### PLANNING COMMISSION AGENDA

**Thursday, June 18, 2020**

3.3. Request: Preliminary Plat approval for Mountain Ridge Phases 1-2, including 94

# Mountain Ridge Engineering DRC Comments June 2, 2020

Oaklie Estates DRC Review Comments- Herriman City Engineering Department

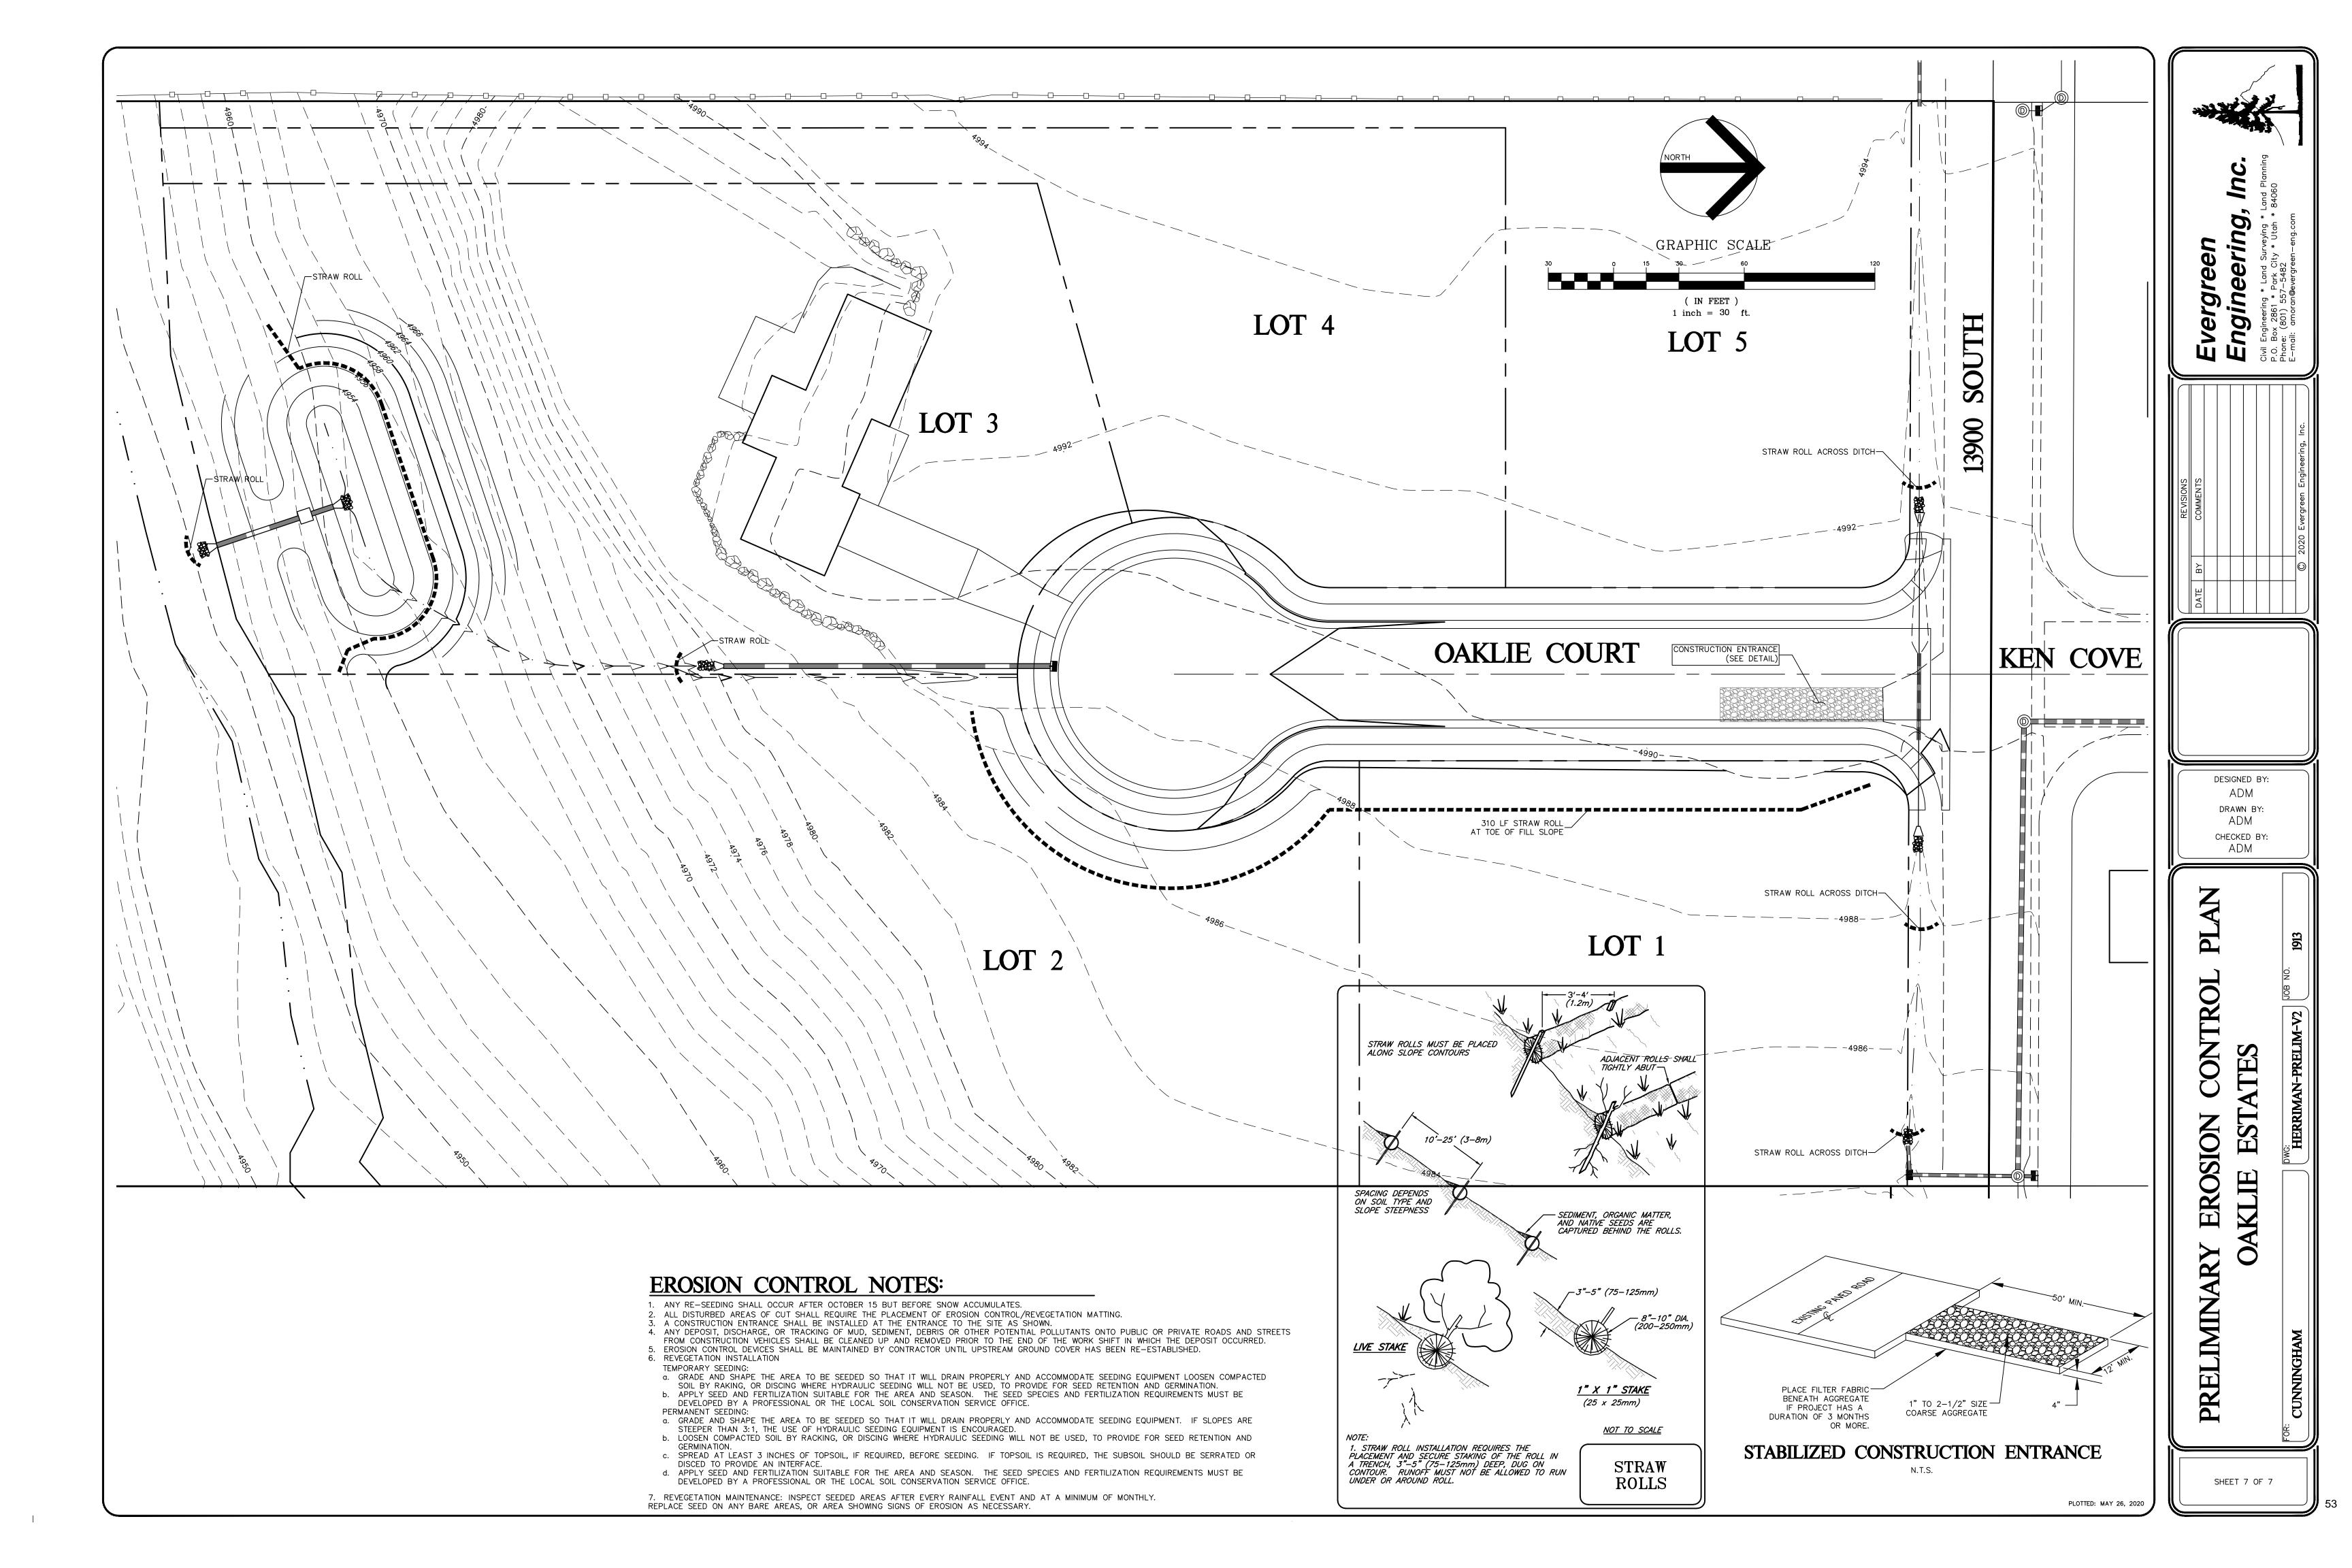
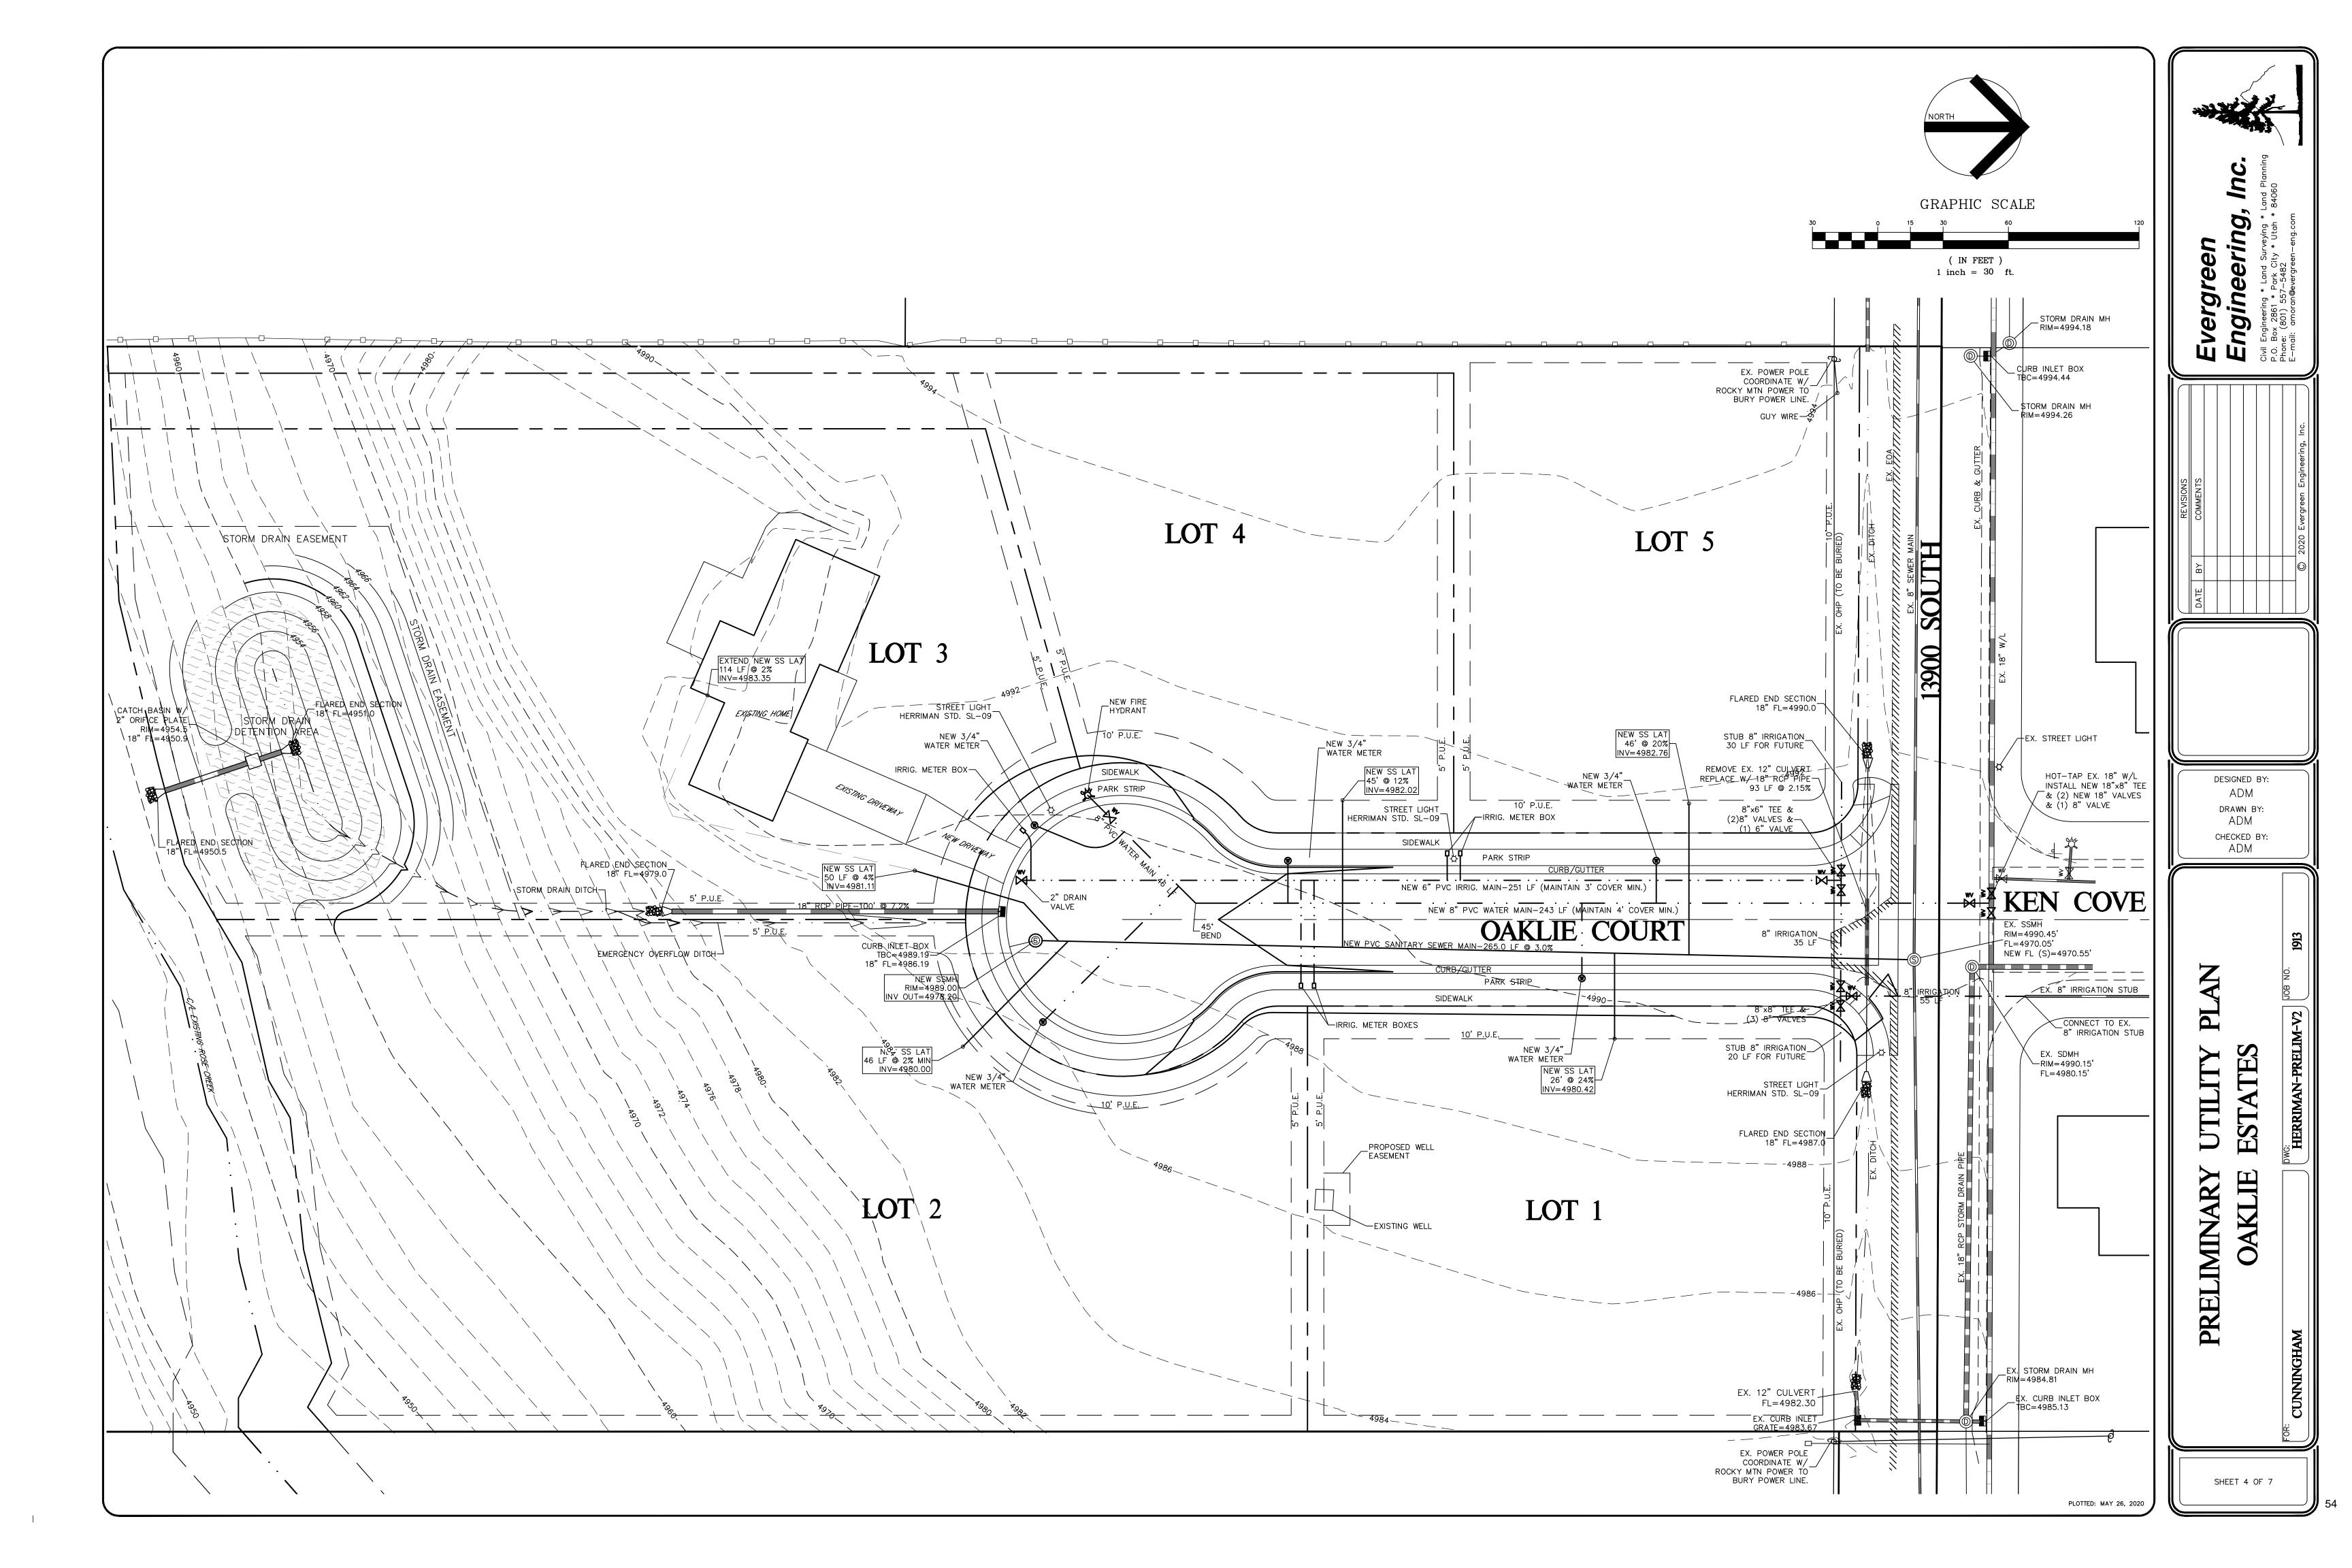
- 10. Provide a stormwater report. Ensure reduced discharge rate of 0.02 CFS.
- 11. Storm drain outfall and detention shall comply with the approved Storm Drain Master Plan.

Work on a plan to get stormwater off the church property. Maybe add a 20 foot trail between the lots and use as a storm drain easement?
